System Energy Resources, Inc.
1340 Echelon Parkway
Jackson, MS 39286-1995

CNRO-2004-00062

SUBJECT: Early Site Permit - Response to Request for Additional Information Letter No. 3

ATTACHMENT 1

Figure 1: Site Wind Rose showing Rarity of Winds from the West

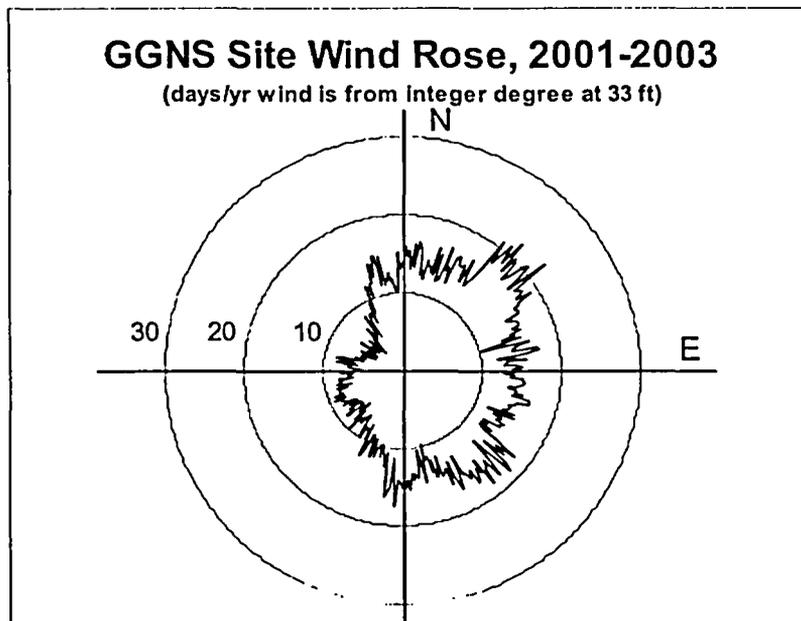
In reference to Section 2.2.3.1.1, flammable vapor cloud explosion hazards are not anticipated on the basis of distance and the existence of a bluff 65 feet above the normal river level. Provide a basis for dismissing river traffic hazards involving natural gas releases. Specifically, consider the possibility of flammable vapor cloud formation involving delayed ignition and taking into account the positive buoyancy of natural gas as it relates to the 65-foot bluff elevation.

The first meteorological condition to be considered is the wind direction. Wind Roses collected from the Grand Gulf Met Tower demonstrate that winds from the west are infrequent. A glance at a typical wind rose (Figure 1 below) leads to the conclusion that should a plume release occur, it probably would not head towards the site, but would rather head along the river (north or south) or towards Louisiana away from the site (wind blowing from the east).

In order to determine the impact of this wind frequency, a conservative envelope of the "at-risk" wind directions had to be developed. It is calculated that the plume width angle might be as much as 35 degrees. If each point on the river is considered, the "at risk" wind direction for each point would be the angle to the site +/- 17.5 degrees. An integration process could be used to determine the fraction of time each wind direction would be an "at-risk" direction as the hypothetical barge moved along the river, however, this would be both complex and would fail to address the possibility of a wind shift moving the plume as a whole.

This review of the 2001 data with the assumed lengths discussed above indicates that the winds were in the "at-risk" directions only 11% of the time. This is a reasonably conservative result considering Figure 1. Note that the 1981 risk assessment (Reference 1) used a parallel development and 1970s era meteorology data to determine that the wind would blow in the direction of the plant site 8% of the time. These results are sufficiently in agreement to provide confidence in the methodologies.
